# #3031189-LU

420 BOYLSTON AVE E **RECOMMENDATION PACKET**

420 BOYLSTON AVE E, LLC | **SHW**

RECOMMENDATION MEETING

BOARD COMMENTS OF SUPPORT:

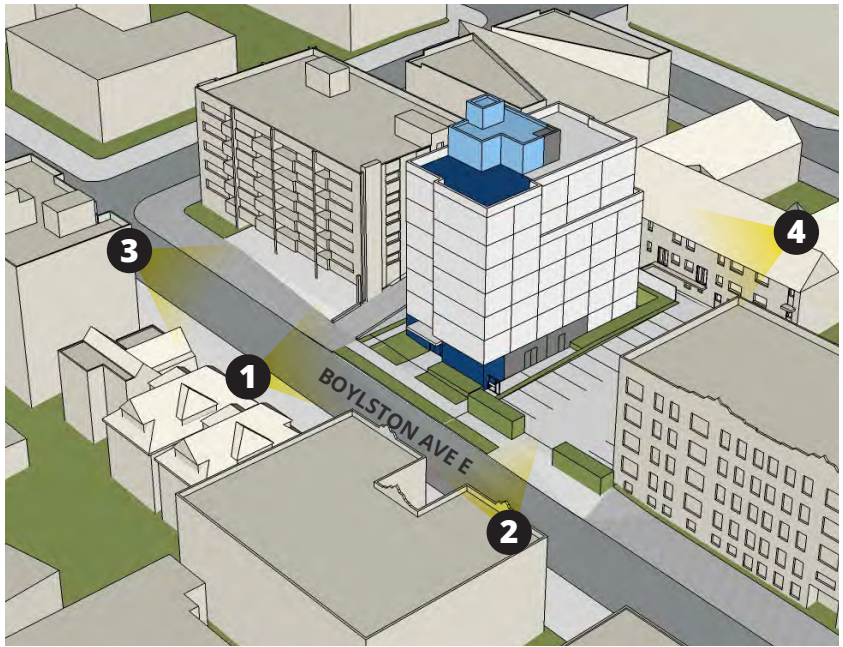
- THE BOARD VOICED UNANIMOUS SUPPORT FOR THE PREFERRED DESIGN, OPTION C.
- BOARD MEMBERS APPRECIATED THE CONCEPT MATERIALS AND INSPIRATION IMAGES AND NOTED THAT THESE MATERIALS AND CONCEPTS WORKED WITH THE MASSING OF THE PROPOSAL.
- THE BOARD APPRECIATED THAT THE VERTICAL CIRCULATION CORES ARE ON THE LEAST VISIBLE PART OF THE SITE.
- THE BOARD NOTED THAT THE REQUESTED DEPARTURES ASSISTED WITH THE DESIGN CONCEPT AND MITIGATED THE HEIGHT OF THE BUILDING.

1 SMC 23.45.518.B - SIDE SETBACK FROM INTERIOR LOT LINE (NORTH)

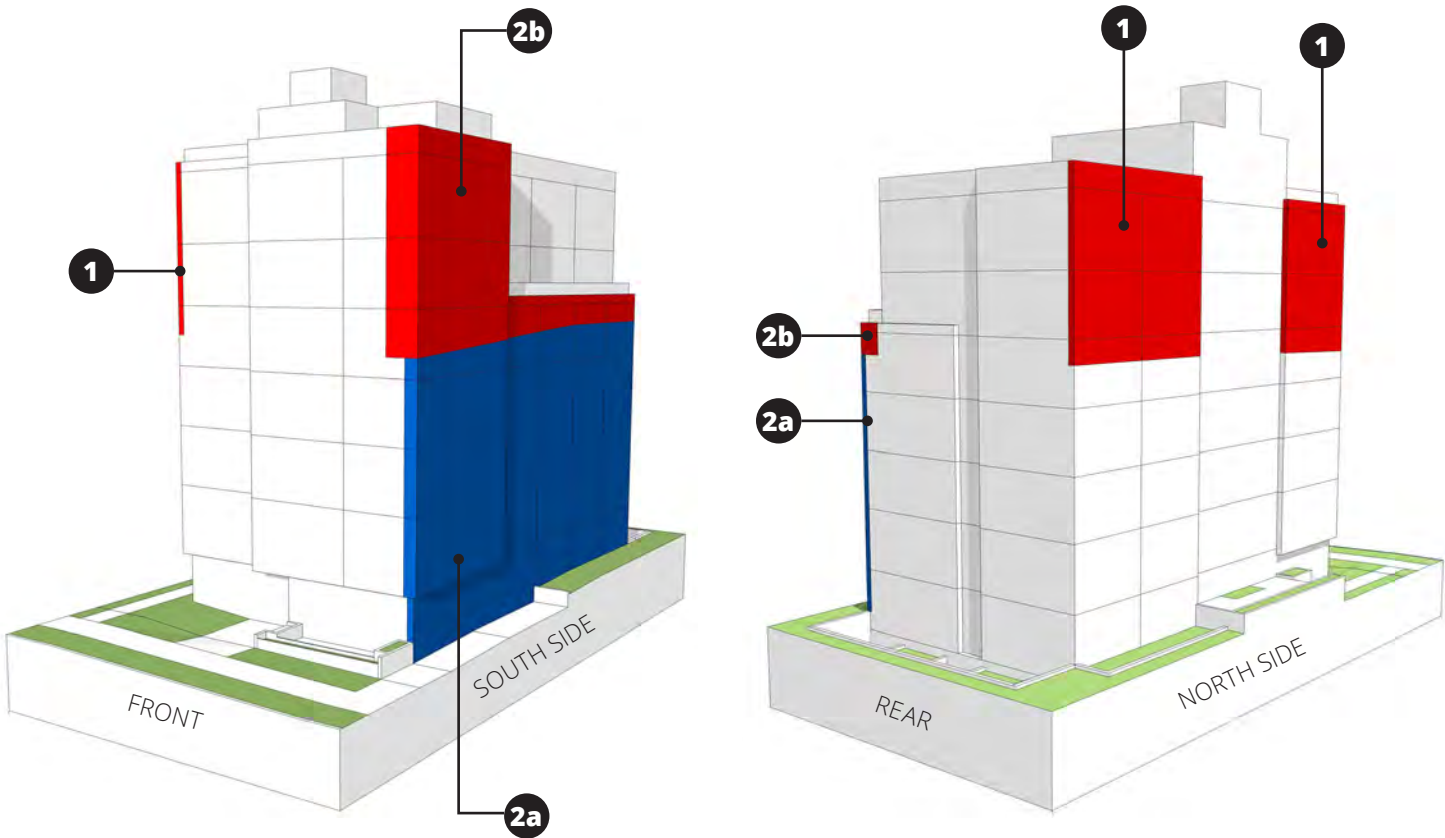
REQUIRED: 7' AVERAGE, 5' MINIMUM < 42' ABOVE GRADE  
10' AVERAGE, 7' MINIMUM > 42' ABOVE GRADE  
PROPOSED: 9.41' AVERAGE, 9' MINIMUM < 42' ABOVE GRADE  
9.43' AVERAGE, 9' MINIMUM > 42' ABOVE GRADE

The building setback below 42 ft is much greater than required and existing conditions at the north neighbor's driveway adds to the large separation between buildings. This request is to reduce the average above 42 ft slightly (not the minimum) to allow for a clear termination at the top of the building and maintain consistent massing expression around the building.

2a SMC 23.45.518.B - SIDE SETBACK FROM INTERIOR LOT LINE (SOUTH)

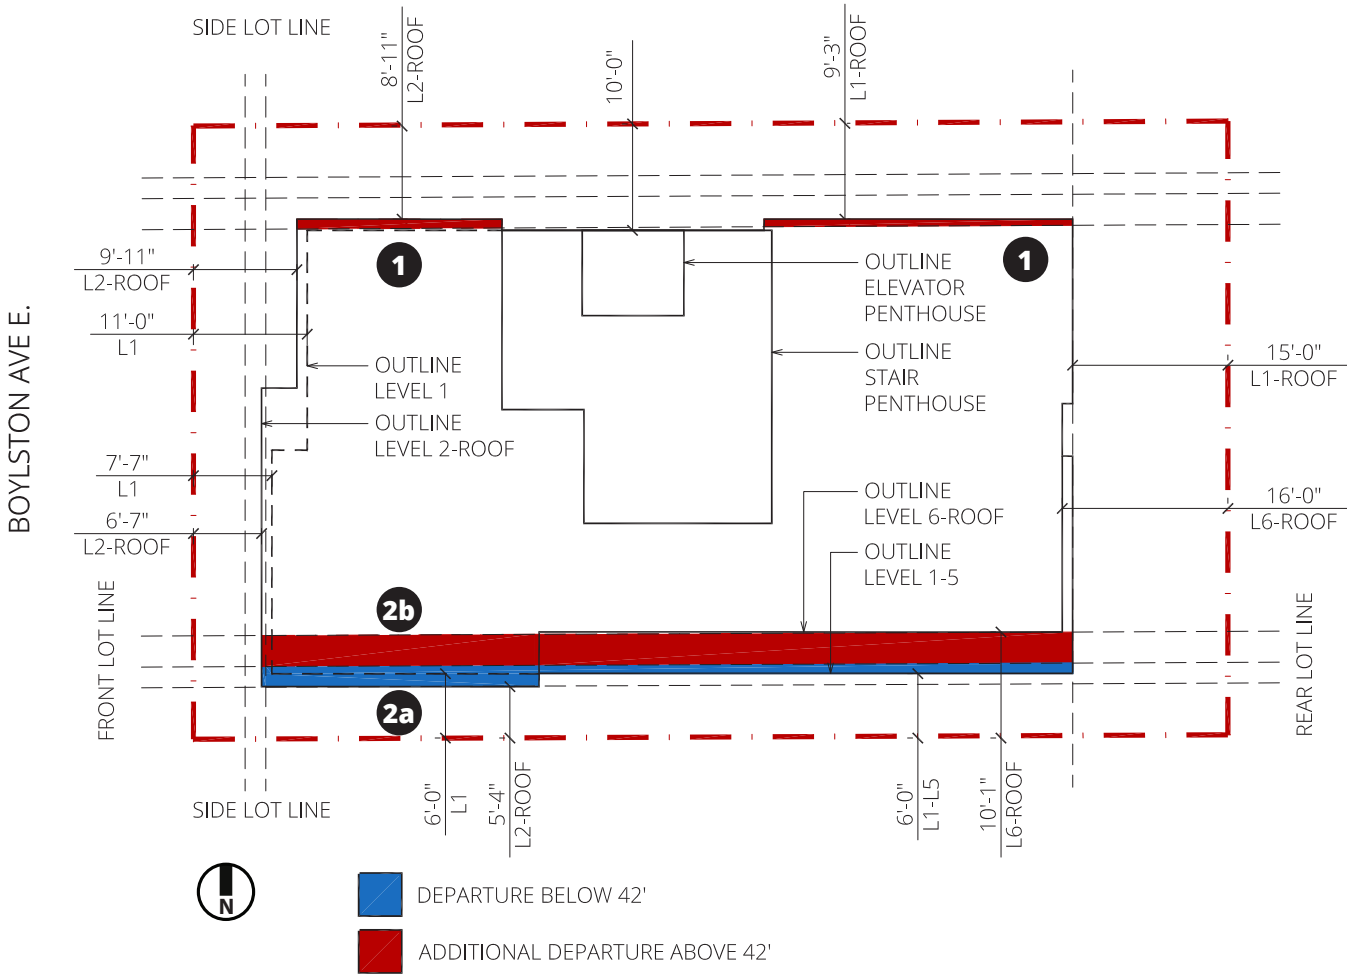
2b REQUIRED: 7' AVERAGE, 5' MINIMUM < 42' ABOVE GRADE  
10' AVERAGE, 7' MINIMUM > 42' ABOVE GRADE  
PROPOSED: 5.81' AVERAGE, 5.33' MINIMUM < 42' ABOVE GRADE  
7.91' AVERAGE, 5.33' MINIMUM > 42' ABOVE GRADE

The proposed side setback is a result of shifting the building mass south to provide an additional buffer to the neighbor and articulate visible facades. The modulation presents a strong corner element where the project is most visible and allows for better massing on the front facade. Upper-level stepping is provided at the side setback and the proposed location was chosen to balance proportion of the overall massing. The stepping terminates at the corner massing to avoid the “wedding cake” style design.
